REMARKS

IN THE DRAWINGS:

Please enter the attached nine (9) sheets of formal drawings (marked "Replacement Sheets") which correspond to the twenty-one (21) sheets of informal drawings originally filed with the present application and correct the informalities noted in Form PTO-948 from the Official Draftsperson mailed June 26, 1996, with Paper No. 5 in the prior application Serial No. 08/482,029 and in Notice of Allowability, Paper No. 6, mailed July 11, 2000, in the prior application Serial No. 09/466,003.

FIG. 7A

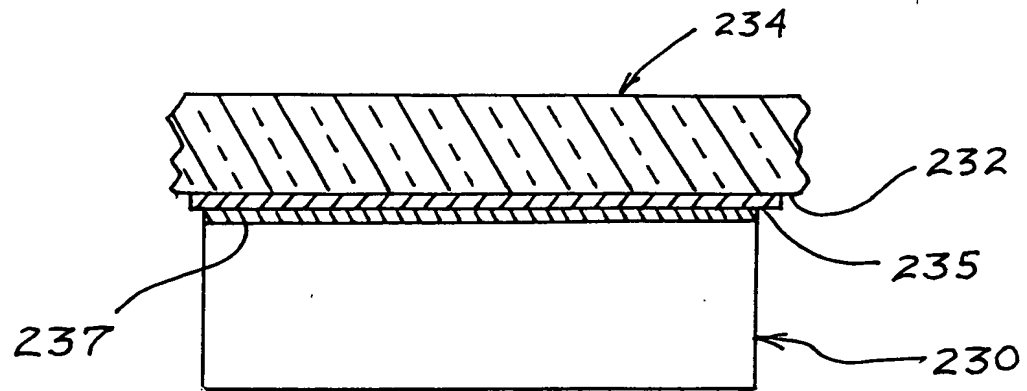
Please amend the drawings by adding Fig. 7A as outlined in red on the attached "Annotated Marked-Up Drawings." Fig. 7A is based on the specification at various places including page 2, lines 28-30 and page 3, line 1, page 6, lines 3-10, page 11, lines 22-28, and original claims 1-4, amongst others. Because Fig. 7A is based on such original disclosure in the specification and drawings of this application as originally filed, it is respectfully submitted that no new matter has been added. Approval and entry of additional drawing Fig. 7A is respectfully requested.
